ADDENDUM NO. 30

PROJECT NO. DGS C-0211-0005 PHASE 005
PROJECT TITLE - PA State Police Academy - Core Bldgs, BESO & Sitework
PROFESSIONAL:
SOM
7 World Trade Center
New York, NY, 10007

Item 1 - **PLEASE NOTE:** This is a re-upload of **Addendum 29**, with attached drawings, specifications and references throughout to **Addendum 29**.

5 SITE WALL
SCALE: 1" = 1'-0"

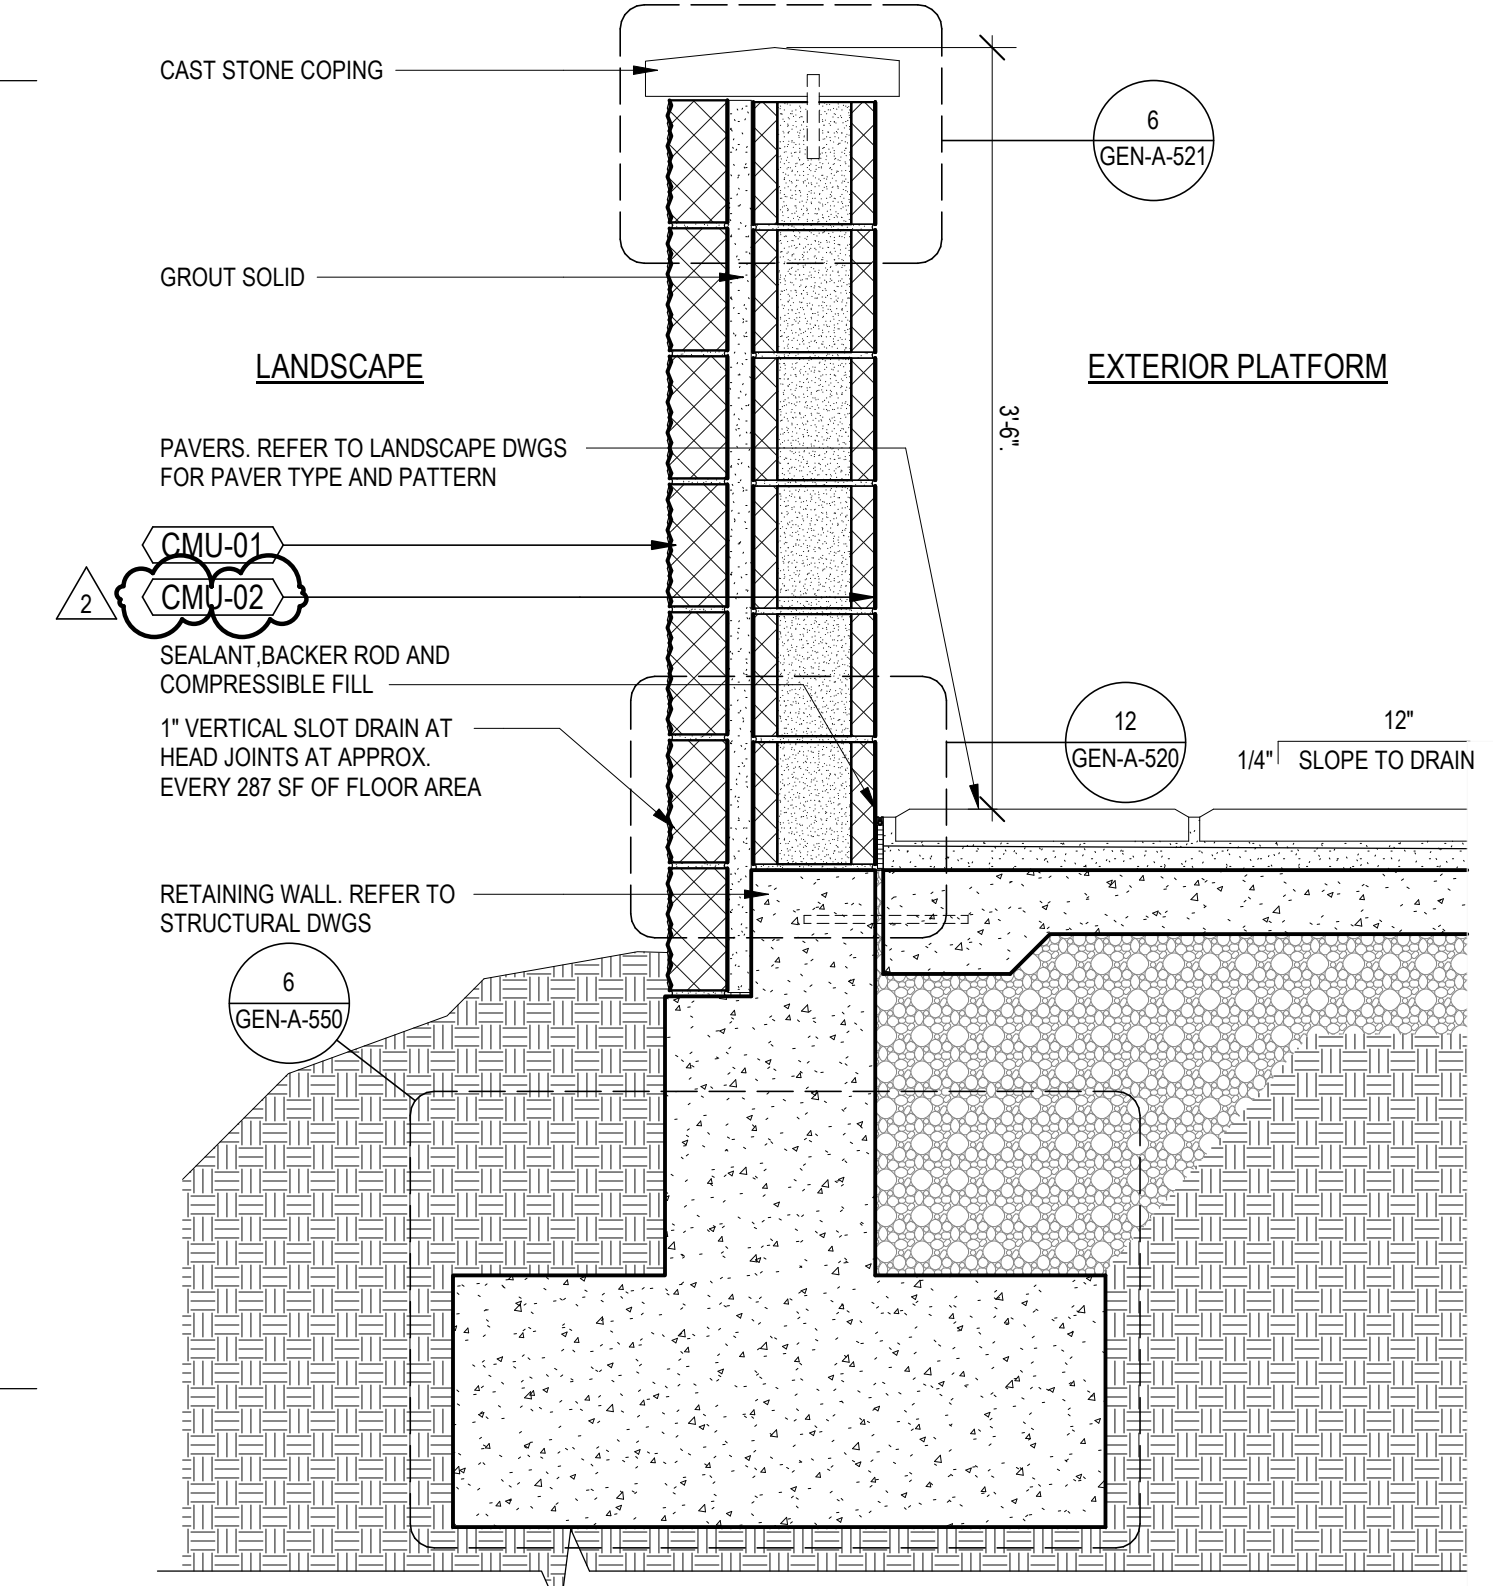
- Question 115: FTU Wall: FTU Site wall detailed on 5/GEN-A-521 indicates a fully grouted CMU backup wall, however, the backup CMU wall is labeled as CMU-01A, which is a 4" split face CMU. Please confirm R2 or N12 is the correct CMU type.

- Response: Site wall to be CMU-02 backup, faced with CMU-01. See 5/, 11/GEN-A-521 as issued in Addendum #29. Please note that CMU-01A is an 8x8x24 block per 042000.2.3.B

8 ON STRUCTURE TO ON GRADE PAVER TRANSITION
SCALE: 1 1/2" = 1'-0"

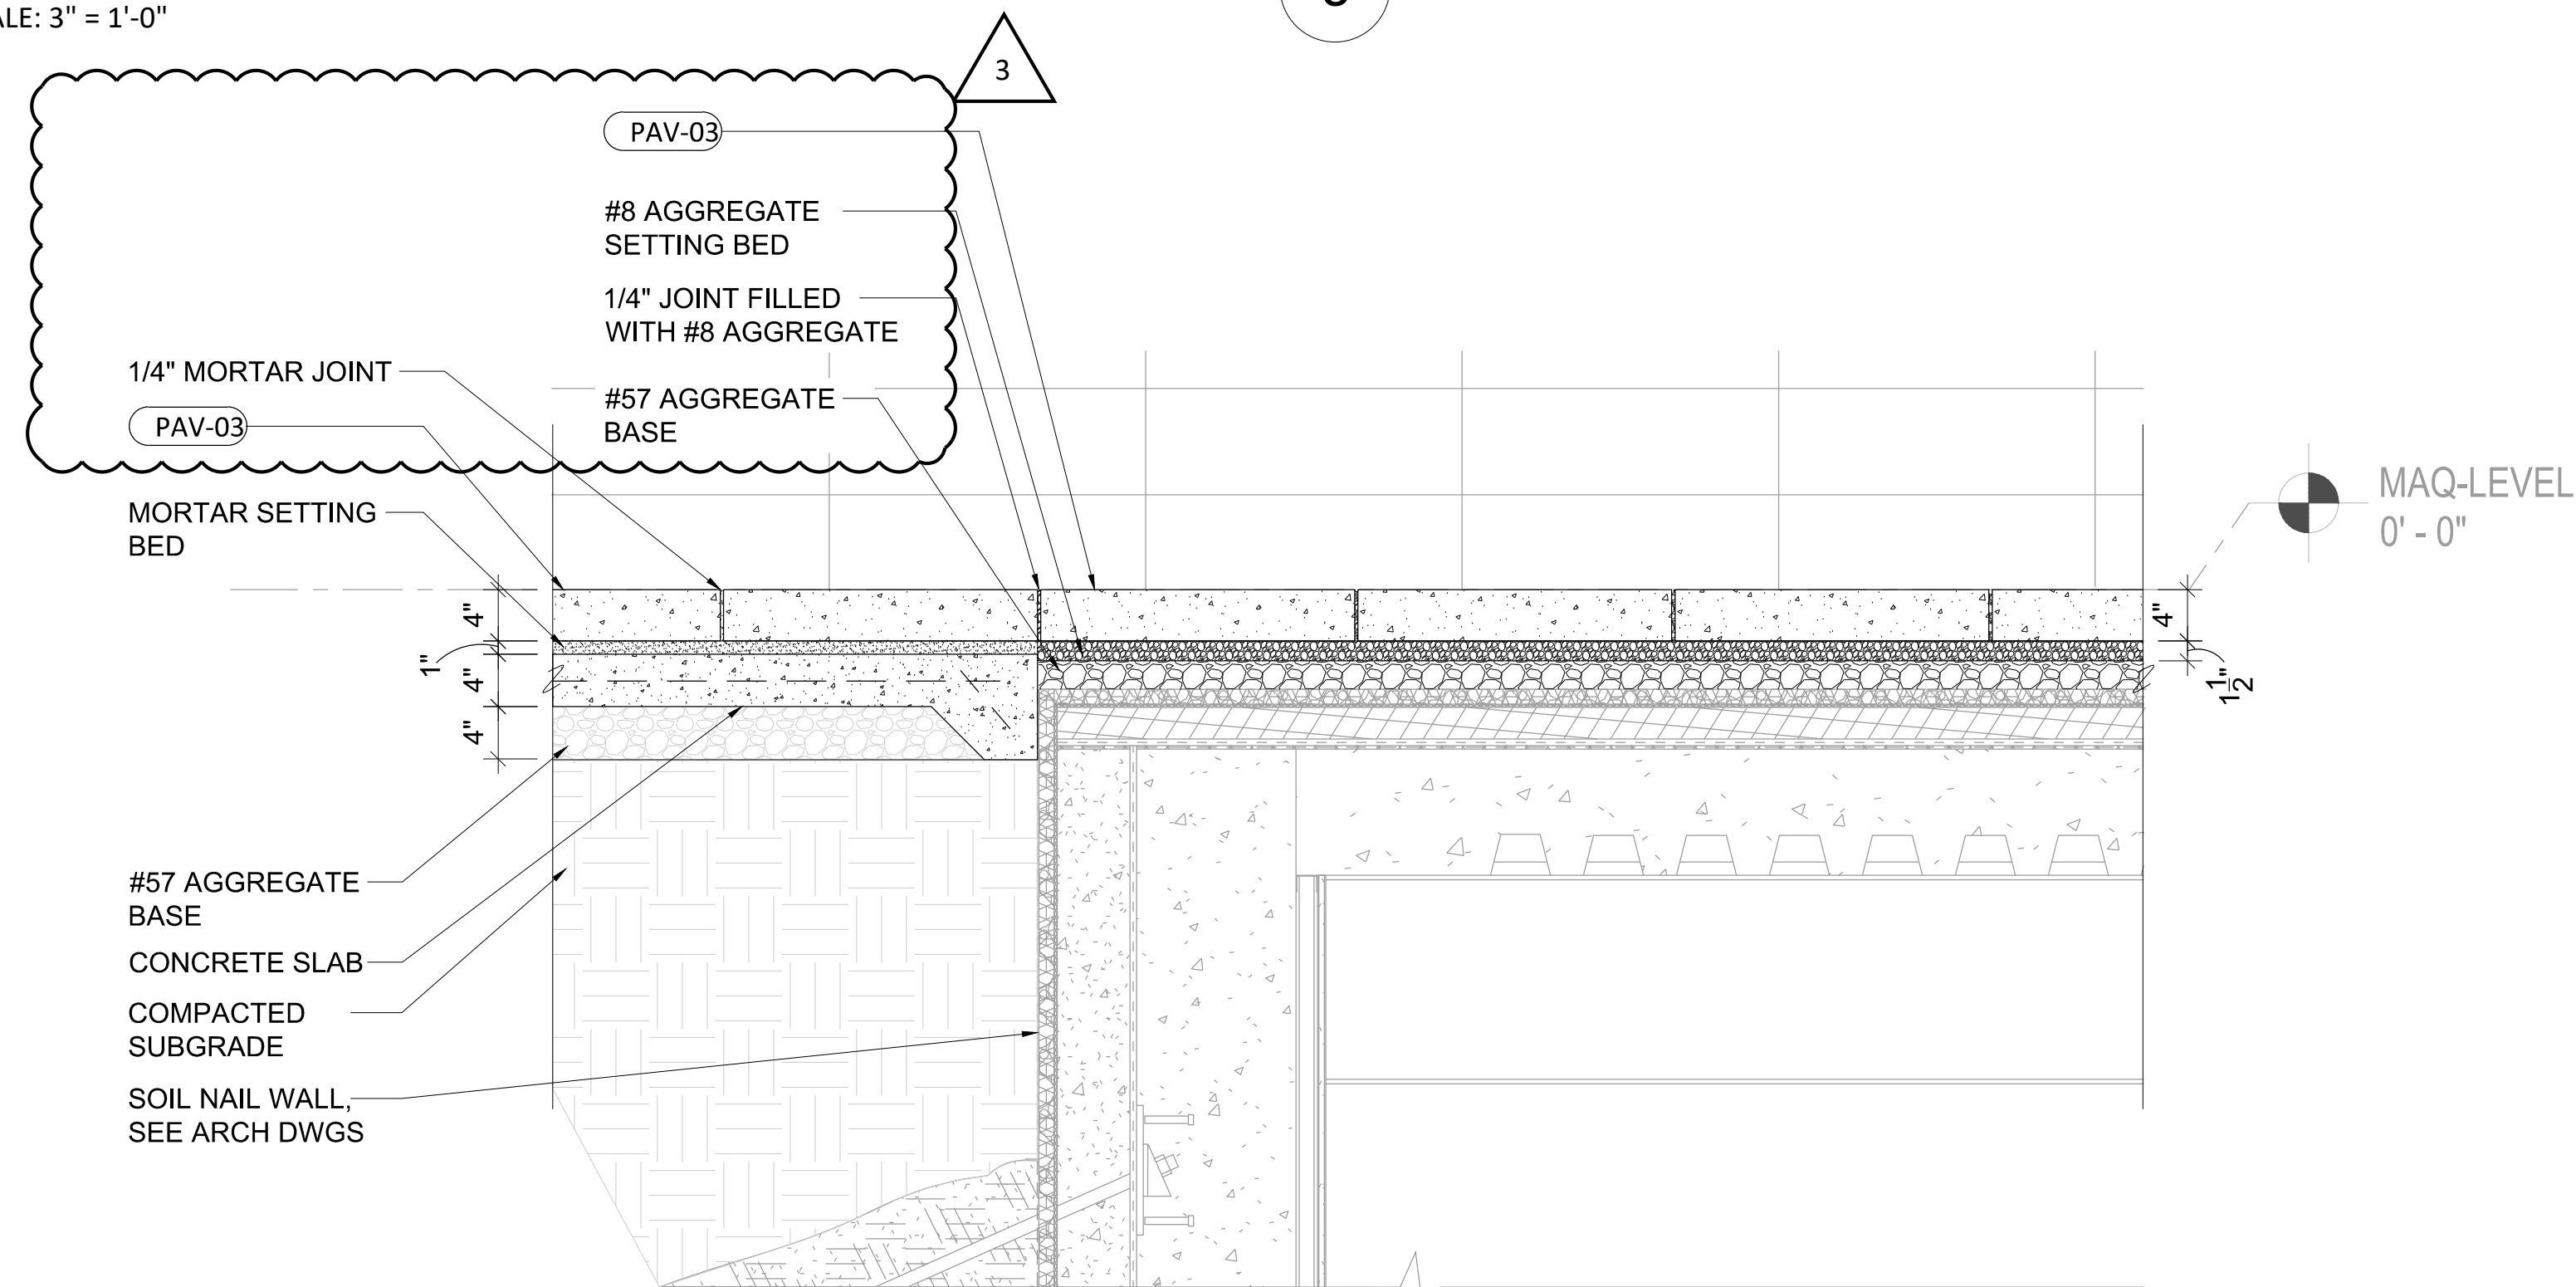
- Question 102: STE-L-900: Please confirm where detail 8/STE-L-900 applied. I don't see where PV 4.0 is set up against the building and the Materials Schedule doesn't show PV 4.0 getting a concrete setting bed below it. PAV-03 is shown up against the building and does have a concrete setting bed underneath.

- Response: Detail occurs at paving that leads to main/central entry to Marquee Building. See revised detail in Addendum 29 drawings which indicates PAV-03 in lieu of PV 4.0.
